**Bellefonte Evacuation Time Estimate Report**

**Supplement 1**

## Bellefonte Evacuation Time Estimate

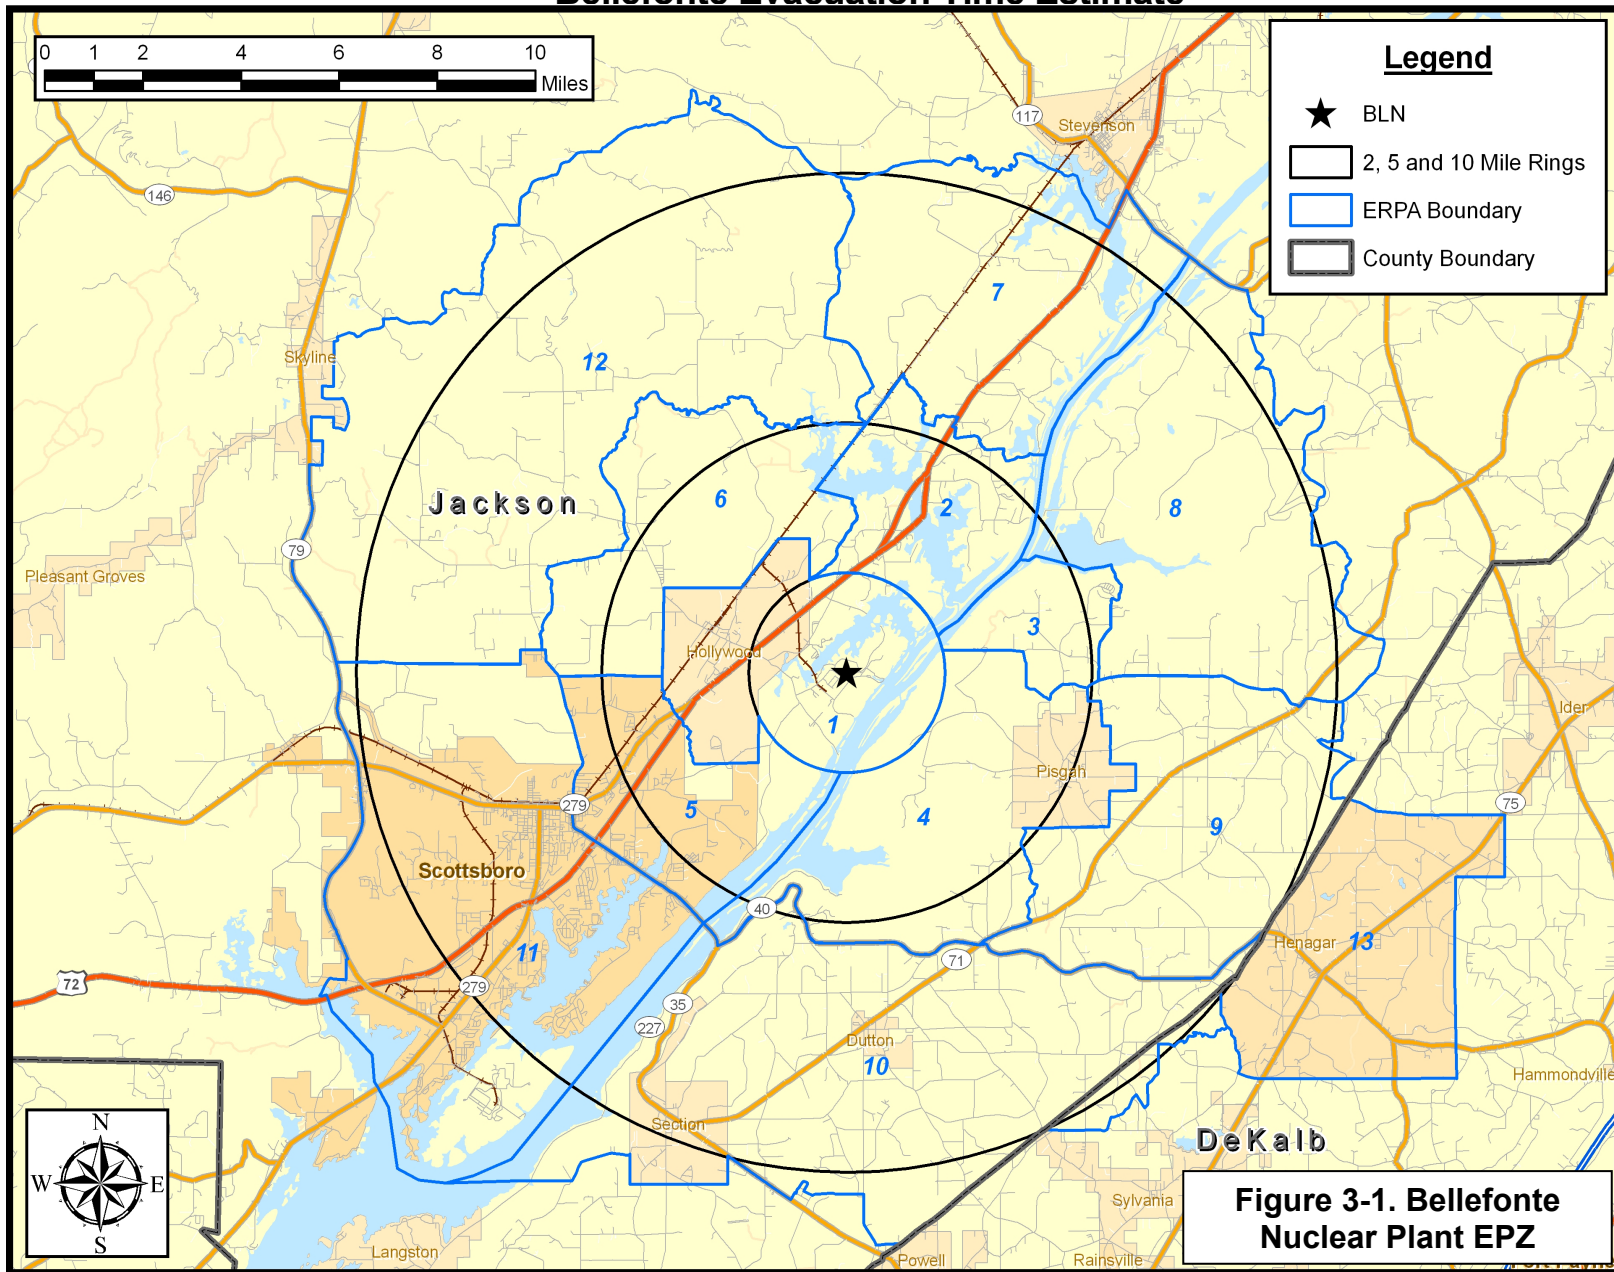
- Updated figure by adding county boundaries to the map, labeling Jackson and DeKalb Counties, and adding county boundary to the legend. See updated figure provided in this Errata Sheet.

**Figure 3-6. Employee Population by Sector**

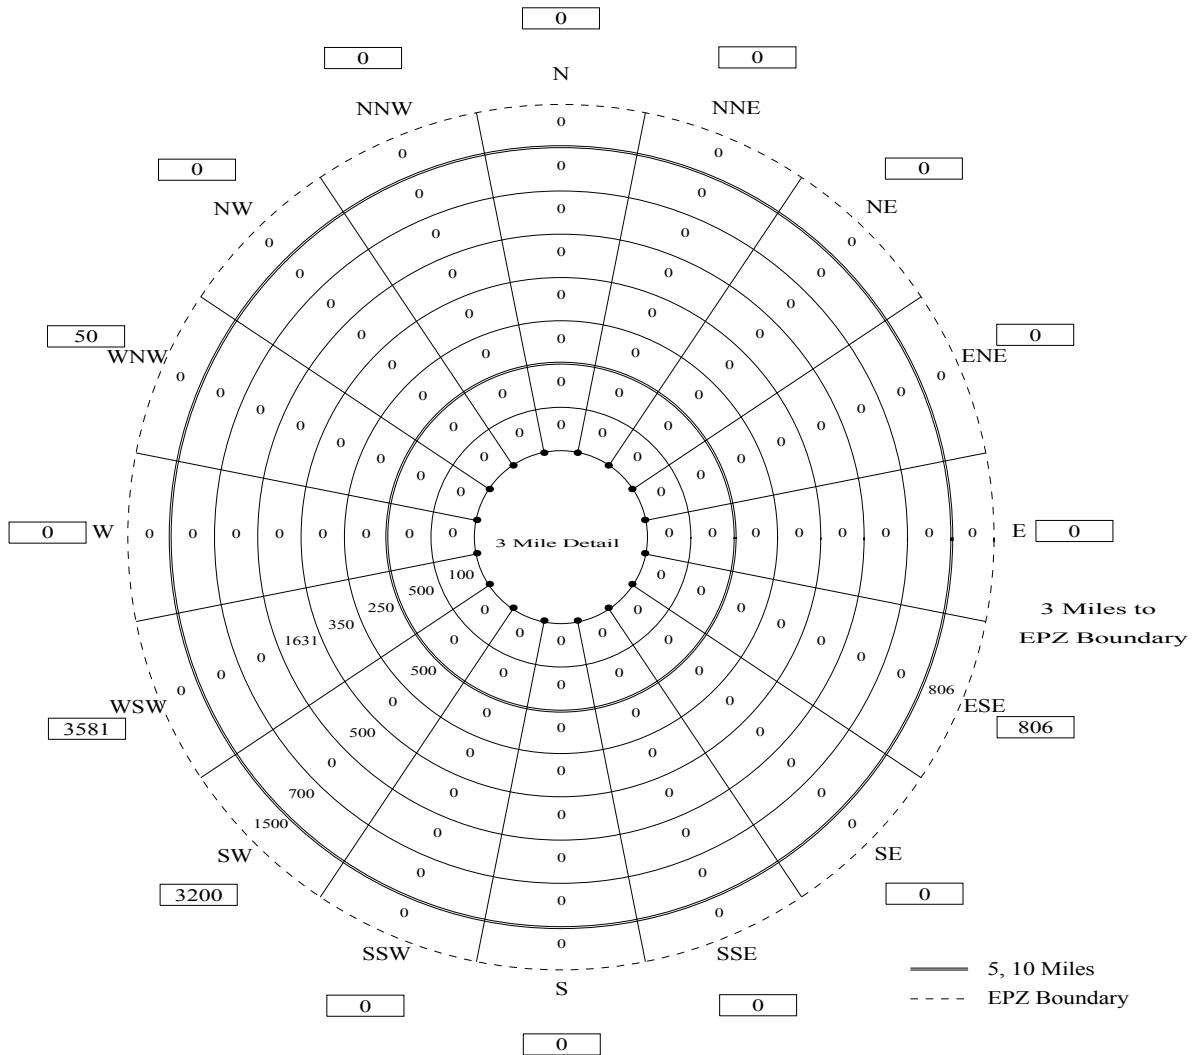
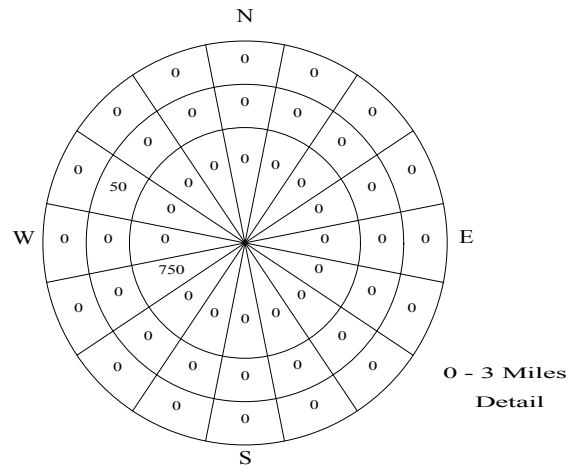
- Corrected by moving the figure “806” for the ESE, 9-10 mile cell to the ESE, 10-EPZ boundary cell. Corrected the table summarizing employees in the lower left corner of the Figure accordingly. See corrected figure provided in this Errata Sheet.

**Figure 3-7. Employee Vehicles by Sector**

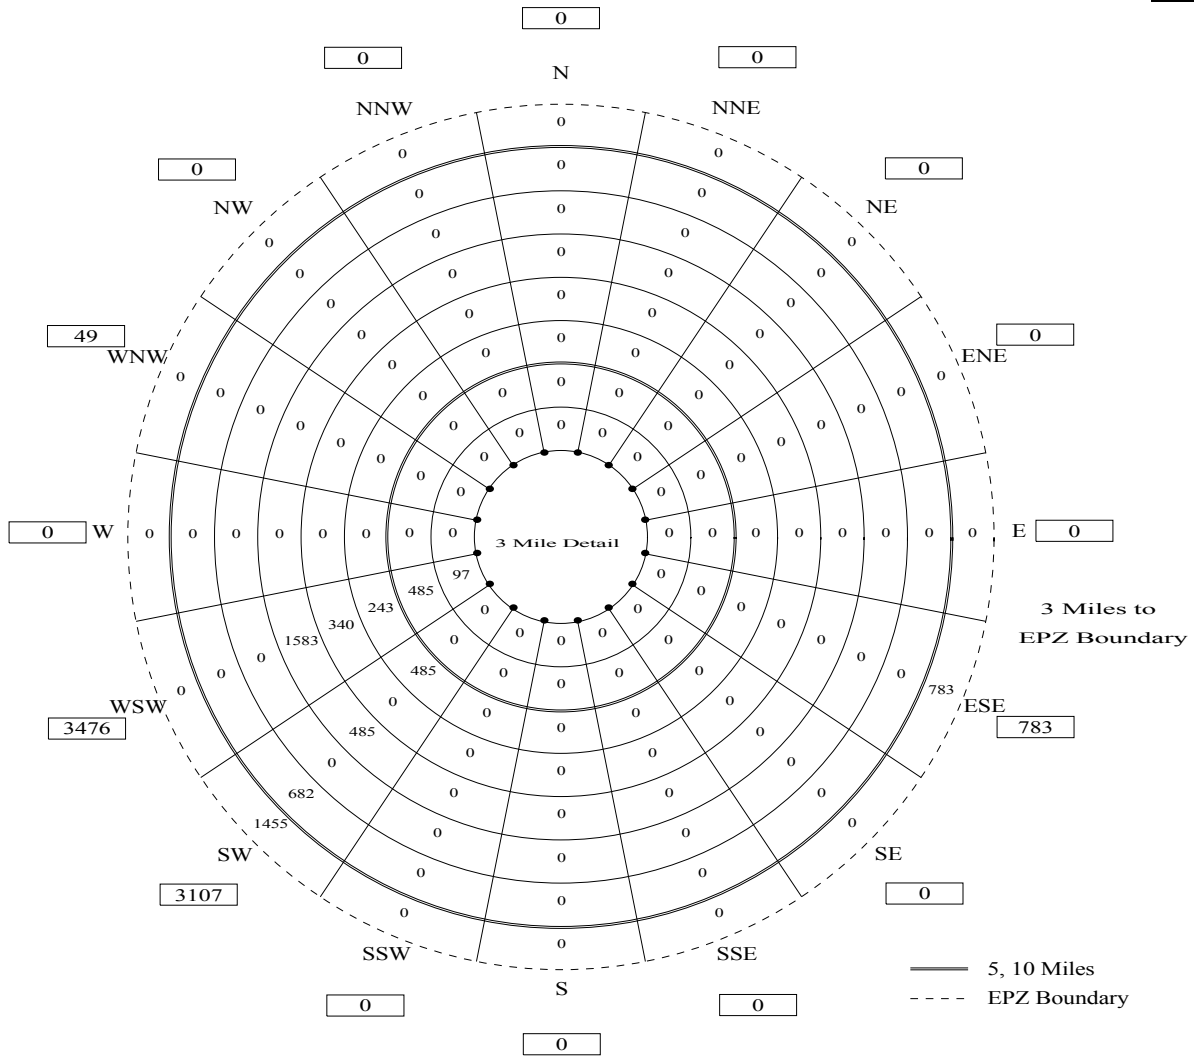
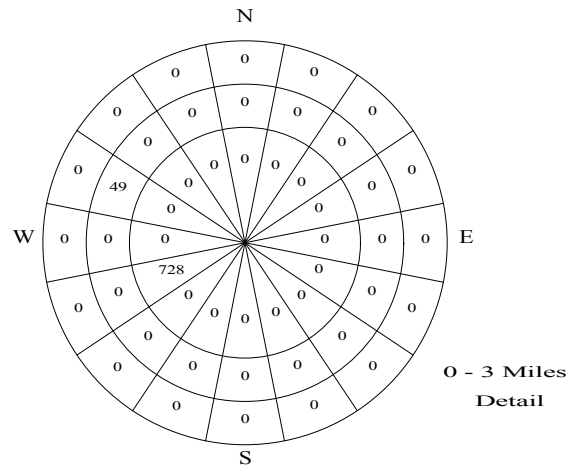
- Corrected by moving the figure “783” for the ESE, 9-10 mile cell to the ESE, 10-EPZ boundary cell. Corrected the table summarizing employee vehicles in the lower left corner of the Figure accordingly. See corrected figure provided in this Errata Sheet.

**Figure 5-1. Events and Activities Preceding the Evacuation Trip**

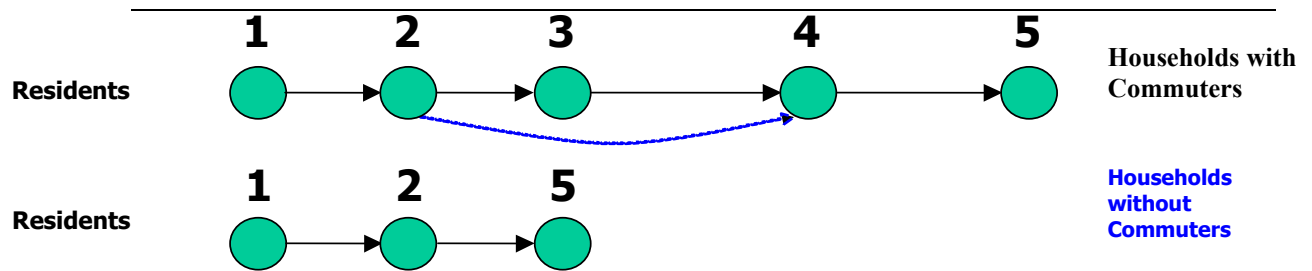
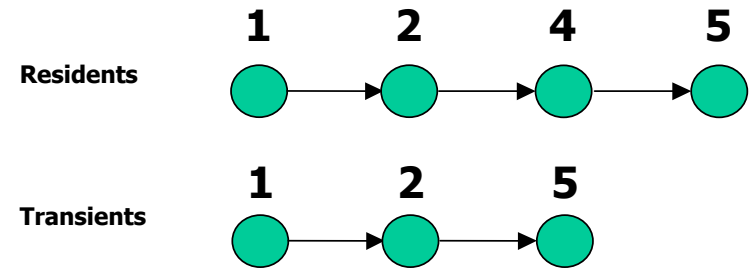
- Corrected Figure 5-1 to agree with the text on Page 5-5. See corrected figure provided in this Errata Sheet.

**Figure E-1. Schools within the BLN EPZ**

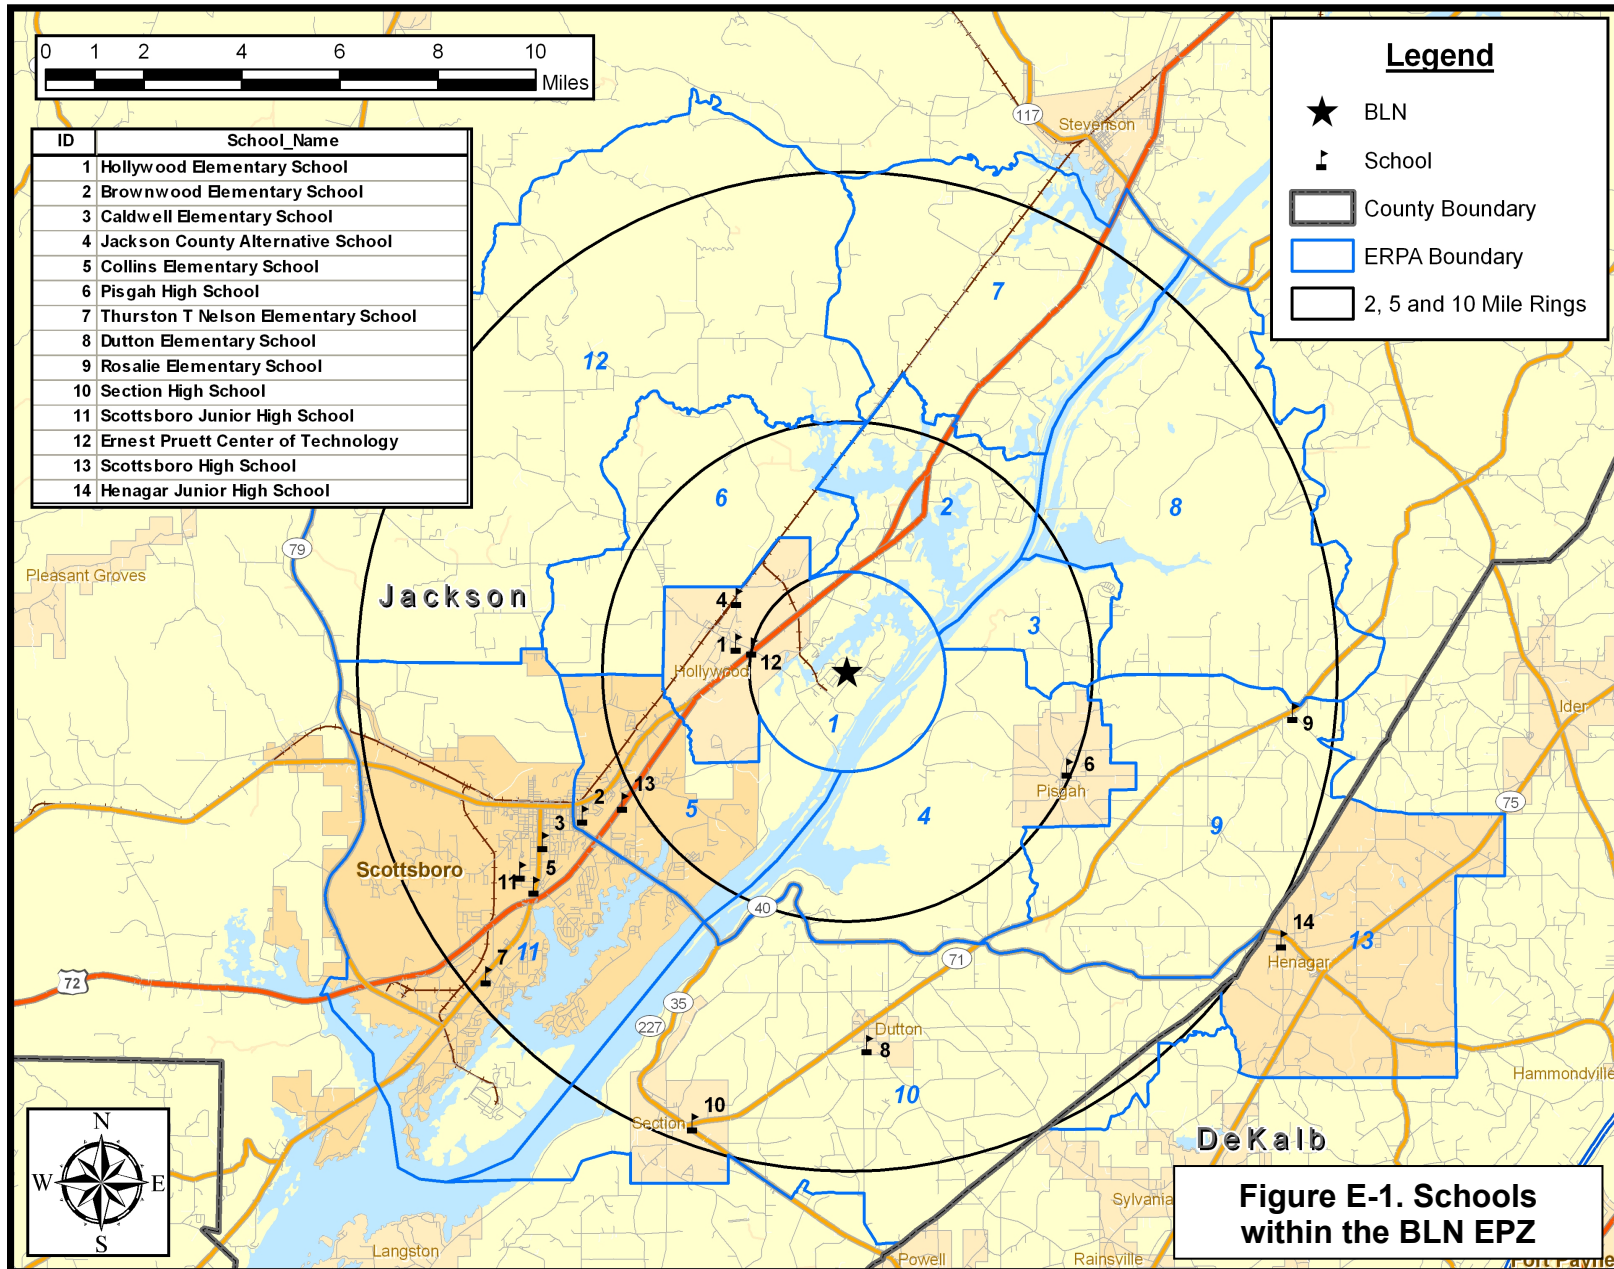
- Supplemented by adding Figure E-1, a GIS map of all schools within the BLN EPZ. See supplemental figure provided in this Errata Sheet.

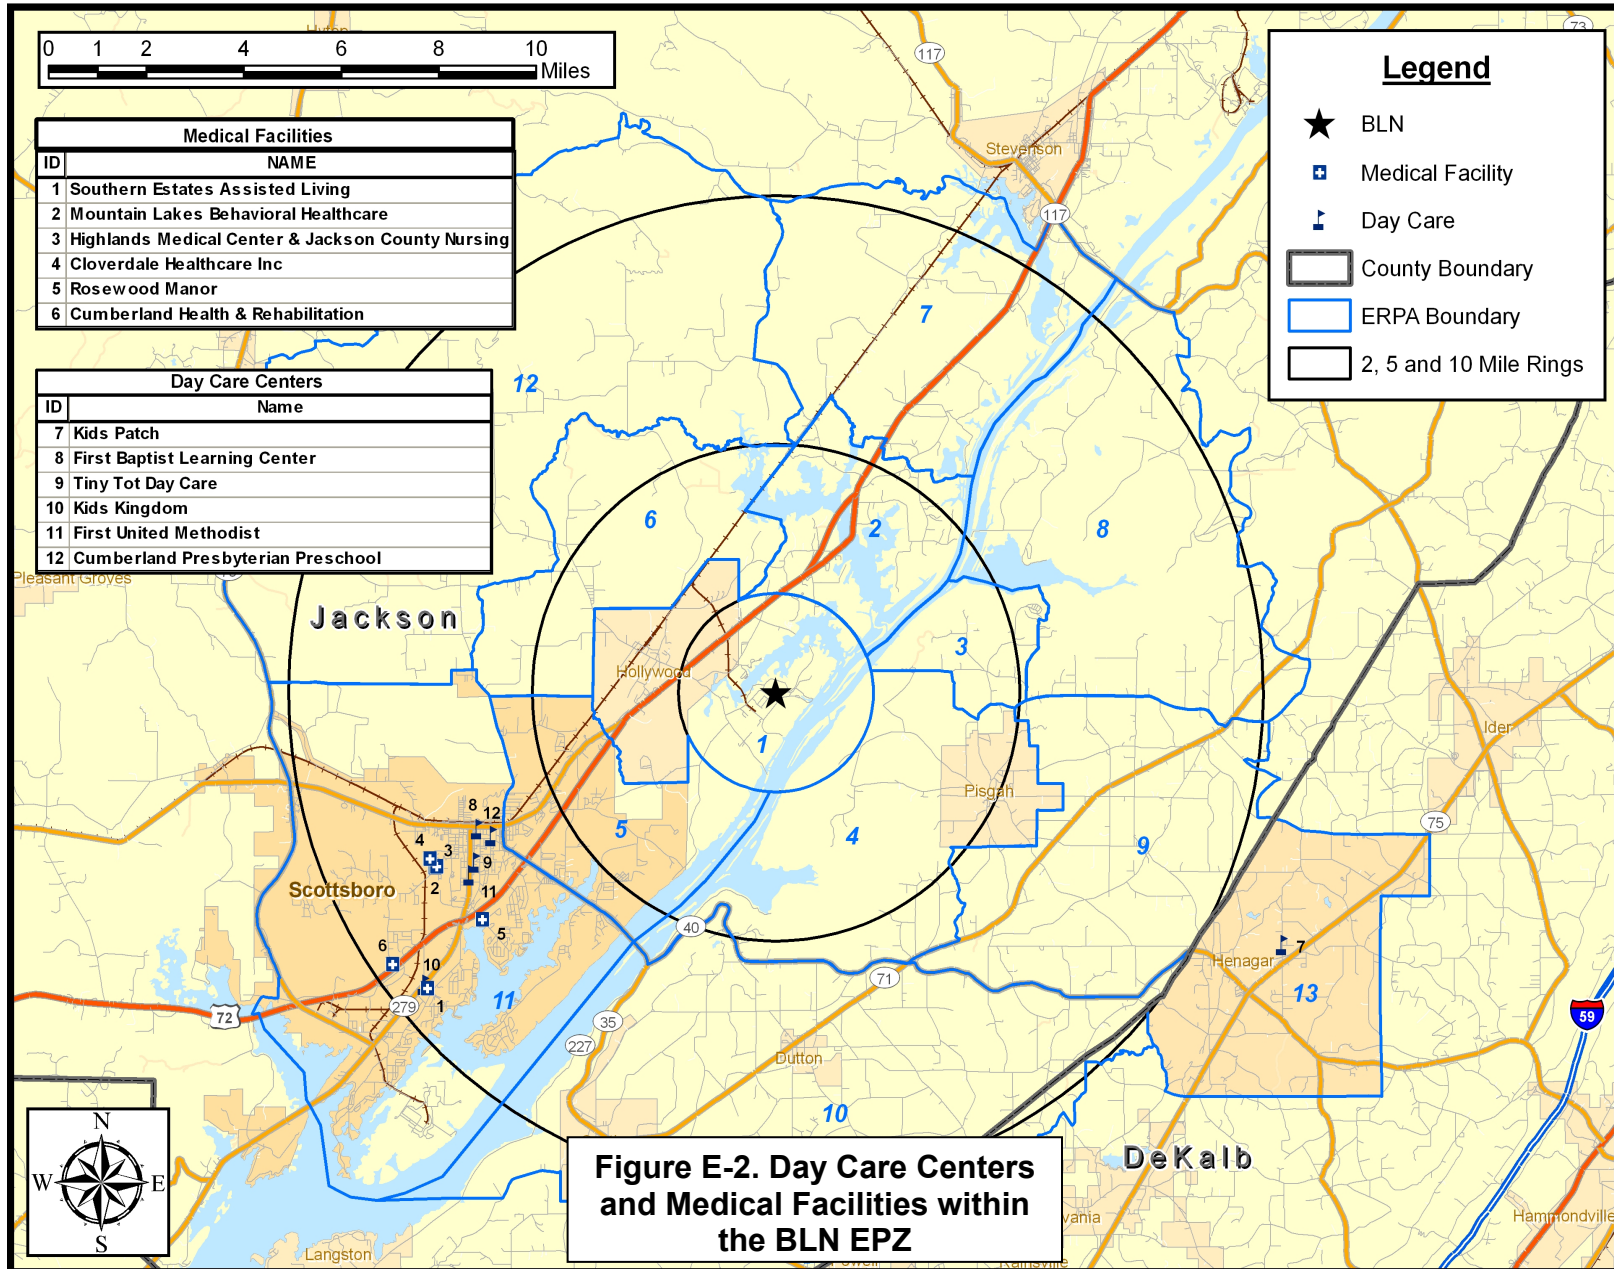
- Supplemented by adding Figure E-2, a GIS map of all day care centers and medical facilities within the BLN EPZ. See supplemental figure provided in this Errata Sheet.
